MESA ENGINEERING
ENVIRONMENTALLY CONSCIOUS CIVIL ENGINEERING
8103 Kirkham Drive
Austin, Texas 78736
(512) 799-7998

May 20, 2012
Engineers Letter
Peaceful Hill Condominiums
Traffic, Number of Units and Drainage Issues
Application: C14-2011-0141

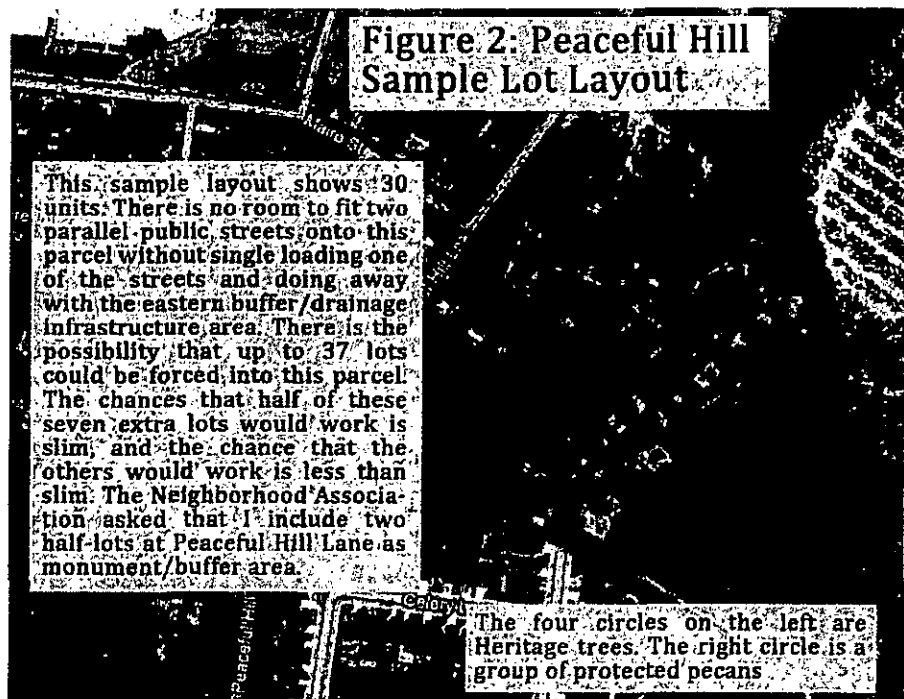
I have prepared an example site layout (see below), using cut and paste (Google Maps) lots from the adjacent Peaceful Hill neighborhood that demonstrates these things.

This layout includes 30 lots. The lots were physically cut and pasted from the Peaceful Hill neighborhood. Accurate measurement of the actual size of these lots is shown in Figure 3 and is found to be 12 percent larger than the minimum lot size for SF-2 of 5,750 feet.

This is the type of estimate I would prepare for my client at this stage of the development process. There is room to add several more lots if we are lucky, if the tree survey and negotiations with the neighborhood over buffers, and issues with the hazardous leaching in the wrecking yard are successfully addressed. These lots would number about three and are located: adjacent to two of the Heritage trees and adjacent to Park Ridge Gardens. In addition one or maybe even two more lots could be situated in the odd triangular leftover space in the

northernmost corner of the property, but these lots are very undesirable. There are also two half-lots at the entry on Peaceful Hill Lane. The Neighborhood Association asked me to leave these two half-lots vacant so as to serve as entry monument lots/buffer area.

The lots size chosen for this sample is also 12 percent larger than the minimum. Ideally, three or four additional lots could be picked up if their sized was reduced to the minimum, but because of the odd shape of this parcel and Heritage trees, it is not likely that any more than one or two lots could be picked up by reducing the size.

Figure Two shows about 50 to 75 feet of vacant land to the east and south of the sample lots. This area is for stormwater facilities and flow spreading. Unless stormwater is piped off-site (discussed below) discharge must leave the site as sheet flow and further, it must be discharge equally along all parts of the site where it would naturally be discharged.

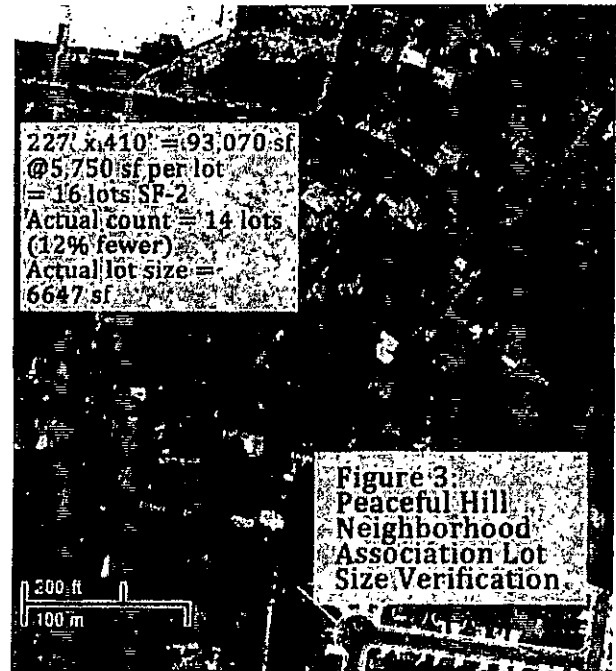
As figure one shows, there is not enough room to provide for a public street loop under SF-2, with houses on both sides of the street. There is enough room for a loop with houses only one side of half the loop, but all lots in the loop must be an odd size; approximately 75 feet x 75 feet and there is no room for drainage facilities on the downhill side, much less a buffer between this parcel and the adjacent parcels.

When the buffer(s) and room for drainage infrastructure are added in, even a loop that is half "single-loaded" is infeasible. The only way a loop is feasible is SF-6 zoning and a site plan using 3,750 sf "condo lots."
